## PLANNING COMMISSION MEETING

February 6, 2023  
4:00 PM

**Administrative Staff Report**  
**Animal Medical and Surgical Clinic of**  
**Wisconsin Rapids**  
**Site Plan Review**  
**1210 River Run Drive**  
**January 27, 2023**

**PROPOSED SITE PLAN & LIGHTING PLAN**

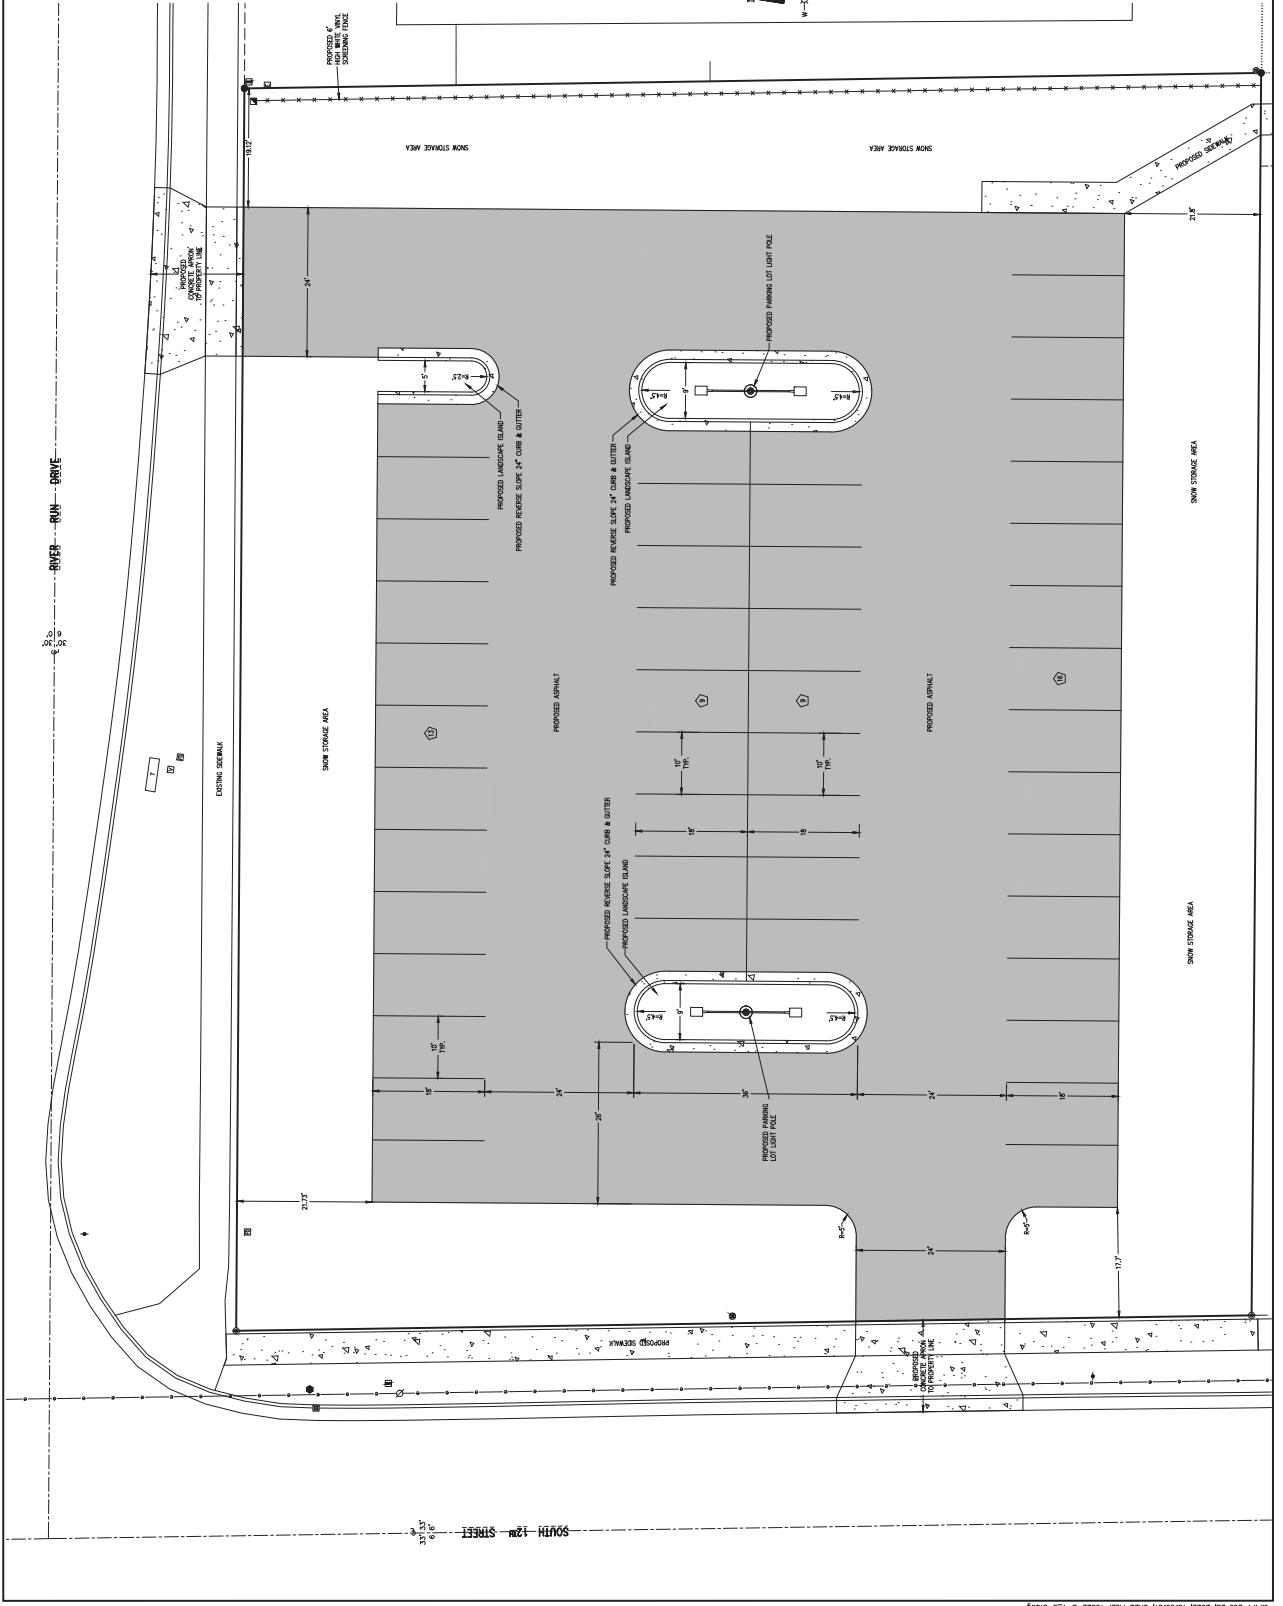
**Findings:** The applicant has submitted a lighting plan. The plan shows the projected intensity of illumination will exceed the permitted standard at the property line to the east. Staff is suggesting the intensity be reduced or a fence be installed to mitigate the impact.

**ANIMAL MEDICAL & SURGICAL CLINIC OF WISCONSIN RAPIDS**  
**PROPOSED PARKING LOT**  
**PARKING PLAN & SIDEWALK GRADING PLAN**

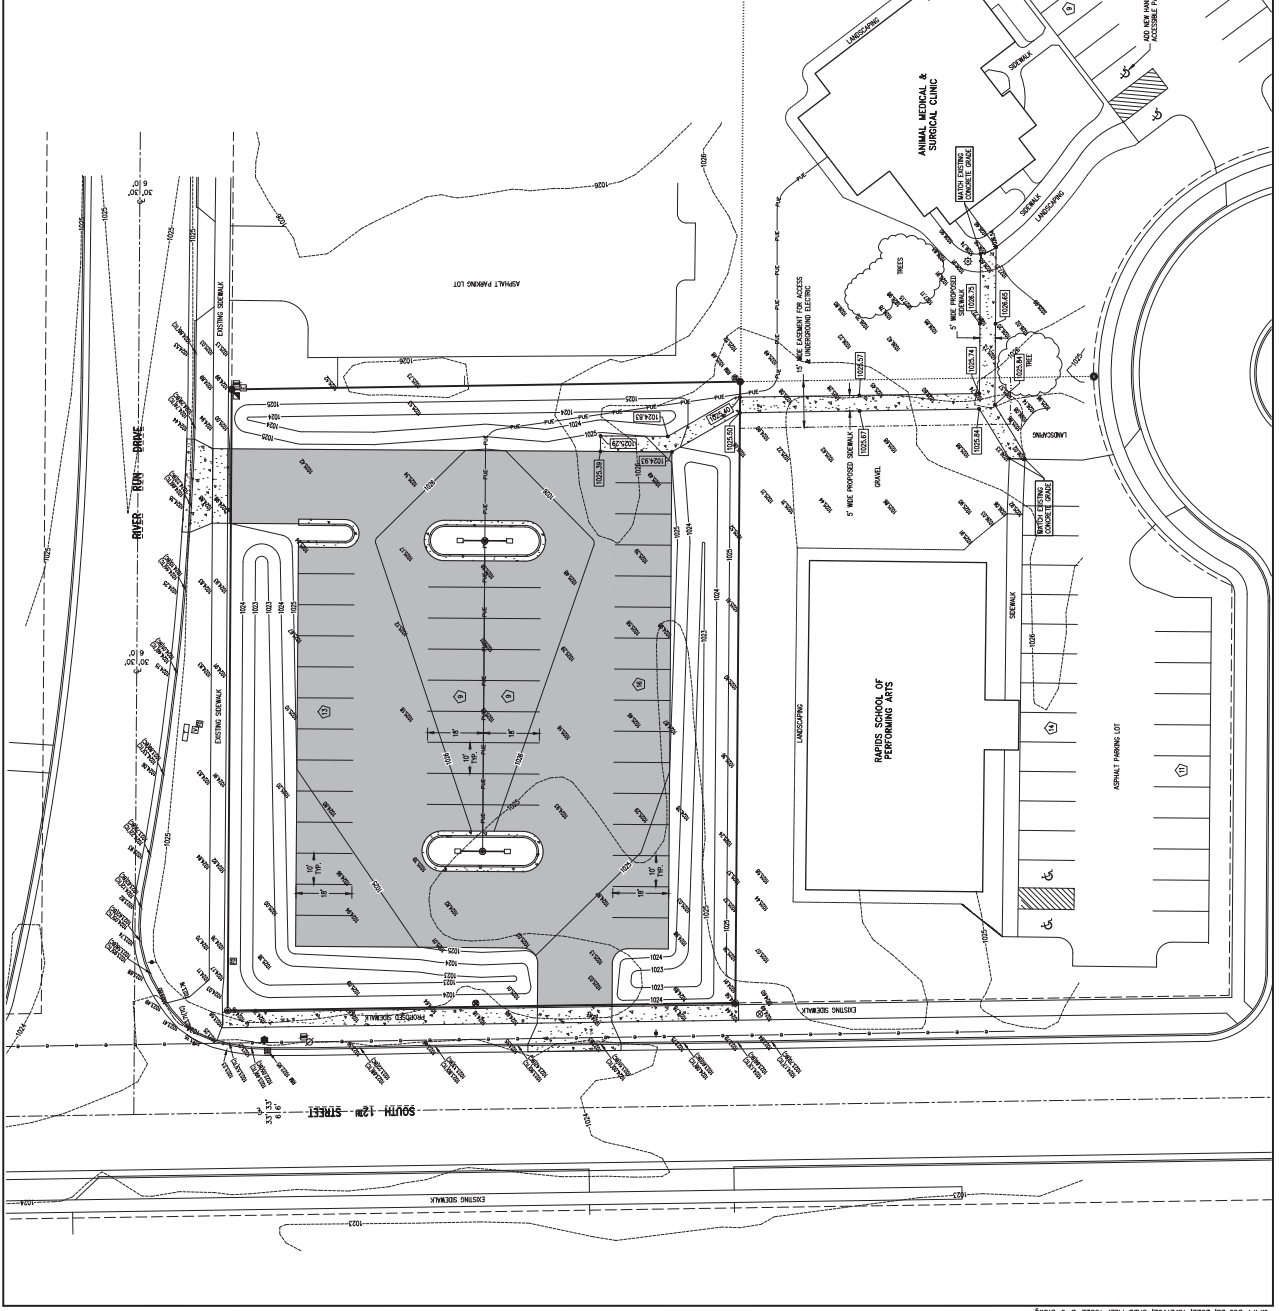
**Analysis:** The use (veterinary clinic, small animal) requires one parking space for each 300 feet of gross floor area, for a total of 9 parking spaces. One ADA approved accessible space is required.

**Findings:** The current development meets the number of required parking spaces. This request is applicant initiated due to the use and operational need for additional parking. The parking deficiency of the adjacent dance studio provides an opportunity for a shared parking agreement. Staff recognizes that the proposed parking is substantially higher than the recommended minimum. When considering the written narrative of the applicant, it is evident that substantial additional parking is necessitated.

The Plan Commission may allow additional parking exceeding 15 percent of the required parking through the Special Exception process. This can be done when the Plan Commission determines that additional parking is needed for the particular use or location. Staff recommends granting the special exception due to the operations and needs associated with the veterinary clinic use.
